County of Albemarle
Department of Community Development
401 McIntire Road, Room 227
Charlottesville, Virginia 22902-4596

Project: West Glen
Plan preparer: Mike Myers, Dominion Engineering [172 S. Pantops Drive
Charlottesville, VA 22911, mmyers@dominioneng.com]
Owner or rep.: Crozet Development Solutions LLC
1215 E. Market Street, Suite B / Charlottesville, VA 22902-5512
Plan received date: 10 Feb 2016
(Rev. 1) April 6, 2016
Date of comments: 27 Feb 2016; revised 11-Mar 2016
(Rev. 1) May 6, 2016
Reviewer: John Anderson
Project Coordinator: Rachel Falkenstein

SP201600003

Engineering comments:

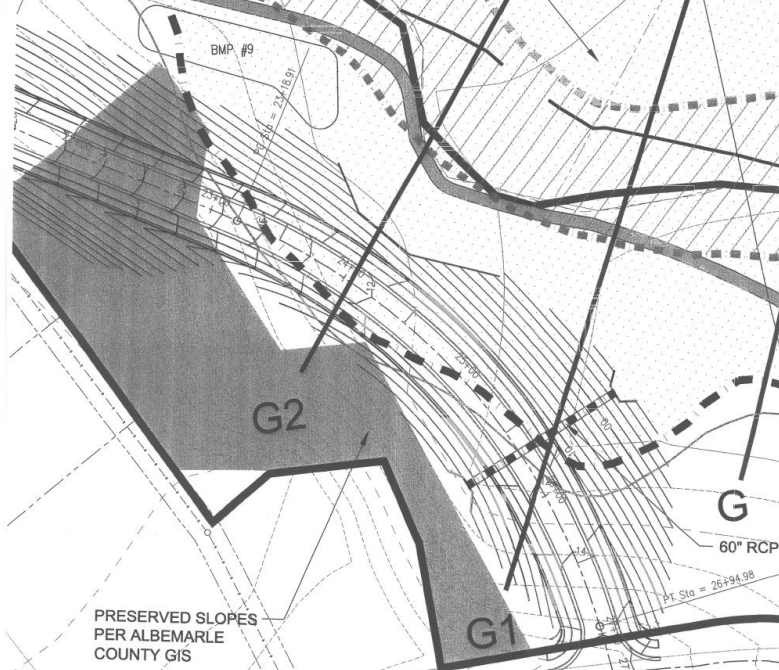
14. SP5/SP6 –Provide (H&H analysis) cross-section upstream of connector floodway fringe/retaining wall. Evaluate effect of proposed (floodway fringe) fill required to construct roadway embankment/retaining wall. [Plan excerpt, below] **(Rev. 1) Addressed.** –Also, see #2, 13, above.
